**Re: Lakeland Power Distribution Ltd. (Lakeland Power)
Application for 2019 electricity distribution rates
OEB Staff Interrogatories
Ontario Energy Board File Number: EB-2018-0050**

OEB Staff Interrogatories
2019 Electricity Distribution Rates Application
Lakeland Power Distribution Ltd. (Lakeland Power)
EB-2018-0050
January 3, 2019

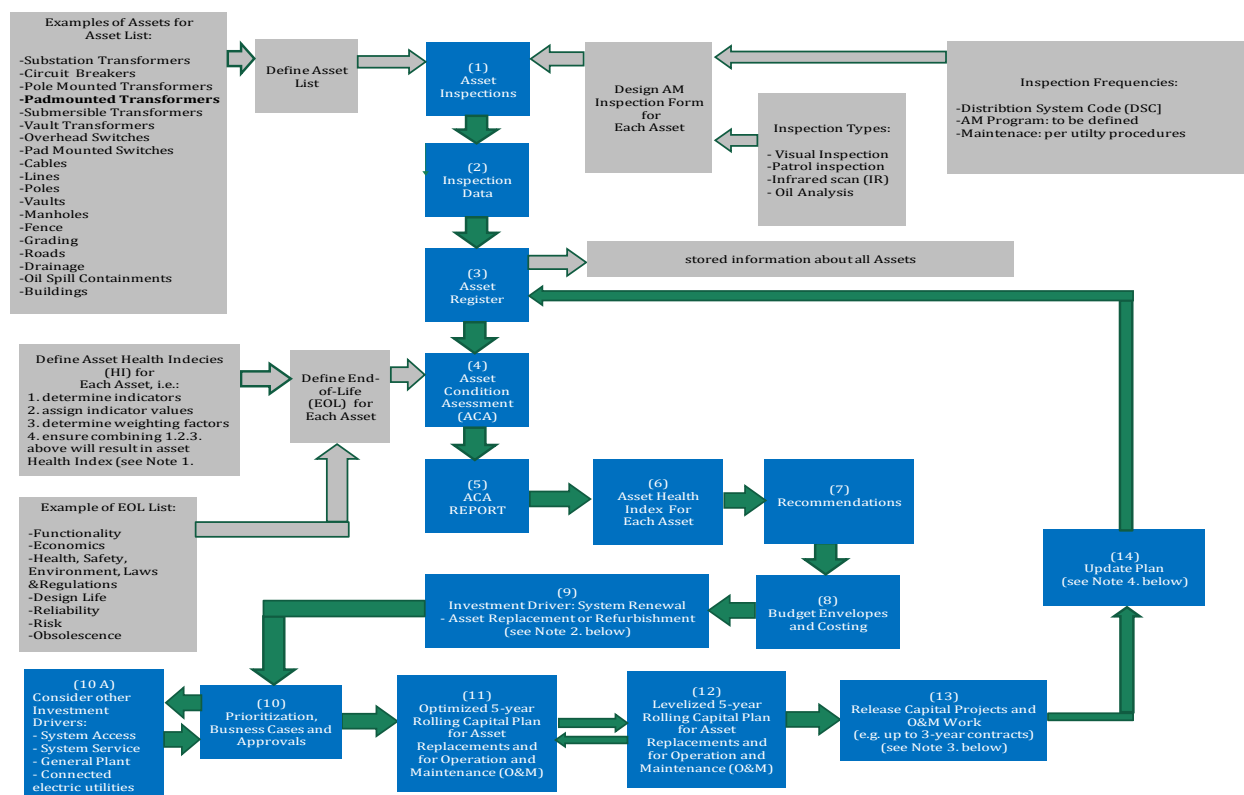
- c) Bullet 4 refers to “Replace end of life assets”. Would you please confirm that this activity is part of an overall Lakeland Power process of “Optimizing the use of resources amongst maintenance, refurbishment/upgrading and replacement”?

- d) In Figure 3-1 “Prioritization of Lakeland Power Objectives”, numerical values are assigned to the Lakeland Power Objectives. Please point to a discussion explaining how these weights were assigned. Maintenance is not included in Fig 3-1. Please explain its absence or confirm how it is included.
